# Access Compliance Report

## Public Rights-of-Way

Intersection ID: 43533	Main Street: REDSPIRE_DR	Cross Street: PLANTERS_WATCH_DR	Location: SW
ADA ID: F1CDBDEE3399	Ramp Type: PerpDiag	Initial Pass/Fail: Fail	Overall Compliance: No
Severity Score: 8.75			
Codes/Mitigation Info/Possible Solution		Field Measurements/Component Compliance

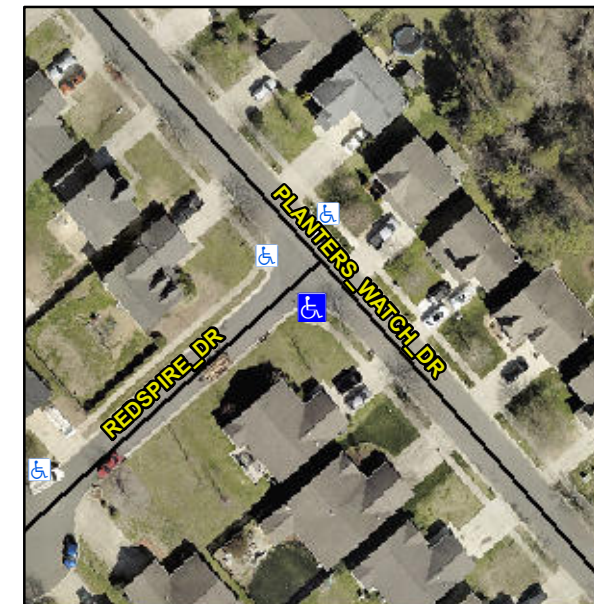
**R304.5.1**

Compliance	Description	Data	Compliance	Description	Data
N/A	Ramp Length (in)	50.0	Yes	Ramp Slope (%)	5.7
No	Ramp Width (in)	40.0	Yes	Ramp XSlope (%)	0.4
N/A	Flare Type LT	N/A	N/A	Flare Type RT	N/A
N/A	Flare Slope LT (%)	N/A	N/A	Flare Slope RT (%)	N/A
N/A	Flare Traversable LT?	N/A	N/A	Flare Traversable RT?	N/A
N/A	Landing Length (in)	N/A	N/A	DWS Provided?	N/A
N/A	Landing Width (in)	N/A	N/A	DWS Contrast?	N/A
N/A	Landing Slope (%)	N/A	N/A	DWS Length (in)	N/A
N/A	Landing X Slope (%)	N/A	N/A	DWS Full Width?	N/A
N/A	Landing Curb? (Y/N)	N/A	N/A	DWS Offset (in)	N/A
N/A	Shared Landing?	N/A			
N/A	Gutter Ponding?	N/A	N/A	Gutter Slope (%)	N/A
N/A	Gutter Lip Ht (in)	N/A	N/A	Gutter X Slope (%)	N/A
N/A	Painted X Walk1?	No	N/A	Painted X Walk2?	No
	X Walk 1 Direction	To NE		X Walk 2 Direction	To NW
N/A	X Walk 1 Width (in)	N/A	N/A	X Walk 2 Width (in)	N/A
	X Walk 1 Slope (%)	0.8		X Walk 2 Slope (%)	0.4
	X Walk 1 X Slope (%)	1.5		X Walk 2 X Slope (%)	2.3

**Remove & Replace Curb Ramp With Two New Directional Ramps or Equivalent.**
